# SUNDANCE GRILL & CANTINA JSP13-56

Consideration of the request of Theodore Andris, PC for Preliminary Site Plan and Stormwater Management Plan approval. The property is 1.89 acres in Section 2, located on the southeast corner of Fourteen Mile Rd. and East Lake Dr. in the B-3, General Business District. The applicant is proposing to construct a 693 square foot addition and a 526 square foot outdoor seating area at the existing Sundance Grille & Cantina.

**TO:** PLANNING COMMISSION  
**FROM:** SARA ROEDIGER, AICP, PLANNER  
**THROUGH:** BARBARA MCBETH, AICP, DEPUTY DIRECTOR  
OF COMMUNITY DEVELOPMENT  
**SUBJECT:** SUNDANCE GRILL & CANTINA, JSP13-56  
SIDEWALK ON FOURTEEN MILE ROAD  
**DATE:** MAY 21, 2014

**TO:** SARA ROEDIGER, PLANNER  
**FROM:** ADAM WAYNE, CONSTRUCTION ENGINEER AW  
**SUBJECT:** SUNDANCE GRILL & CANTINA,  
REVISED PRELIM SITE PLAN JSP13-0056  
**DATE:** MAY 20, 2014

SHEET 2

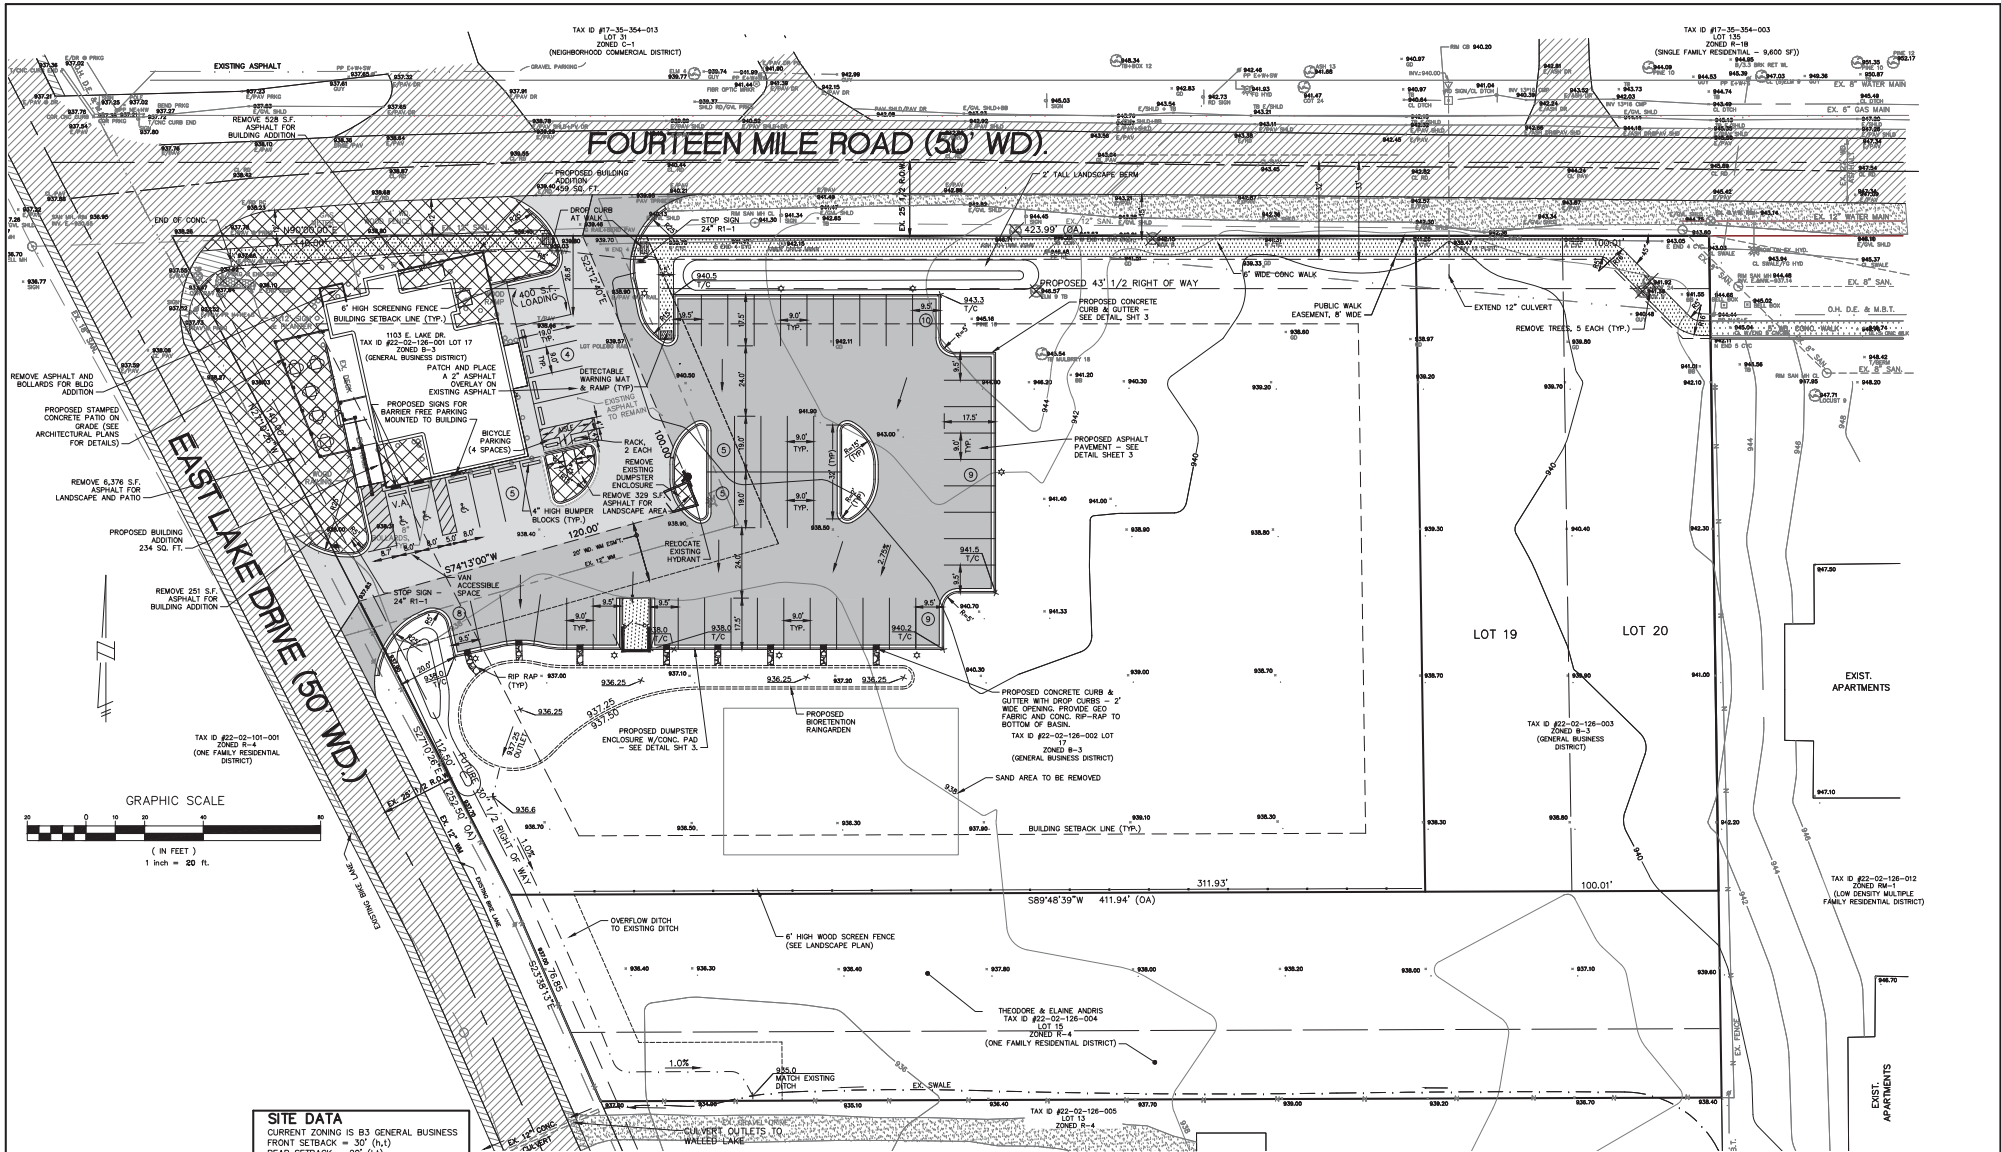
As discussed at the May 14, 2014 Planning Commission meeting, the site plan for Sundance Grill and Cantina was tabled to allow the applicant to submit revised plans illustrating the required 6 foot sidewalk along Fourteen Mile Road. Please see the enclosed memo dated May 20, 2014 and updated Sheet 2 dated 5-16-14 that include the required 6 foot wide concrete sidewalk. The revised plans also include additional detail on the bike parking facilities, which also provided for two additional vehicle parking spaces. The applicant has also included a connection from the parking lot to the proposed sidewalk.

The applicant's engineer has provided the attached plan sheet which now shows a six (6) foot wide pedestrian safety pathway along Fourteen Mile Road. Per the provided plan, the applicant has provided the minimum pathway setback from the edge of pavement of twelve (12) feet. The plan would still require a Design and Construction Standards Variance from Section 11-278(b)(5) of the Novi City Code for a pedestrian safety pathway located more than one (1) foot away from the future right-of-way line otherwise the applicant would need to revise the proposed pathway alignment to fully comply with the Novi City Code.

As directed by the Planning Commission during their meeting on May 14, 2014, we have added the Fourteen Mile Road safety path. The following is a summary of the plan changes.

1. A 6-foot wide concrete walk is now shown adjacent to Fourteen Mile Road from the Beechwalk Apartments located to the east of the site, and connecting to the bicycle lane on East Lake Drive. This path is located within an 8-foot wide public easement for safety path purposes. The southerly edge of the walkway is 32 feet from the centerline of Fourteen Mile Road.
2. A 5-foot wide concrete walk is now shown as connecting to the new path and extends into the new parking lot.
3. The bicycle parking layout is provided and includes 4 parking spaces with aisle ways per the ordinance requirements.
4. Two more vehicle parking spaces have been added in the area next to the bicycle parking space.
5. The parking lot landscape berm has been shortened to a height of two feet.

Staff continues to recommend approval of the site plan with the condition that the sidewalk be installed as depicted.
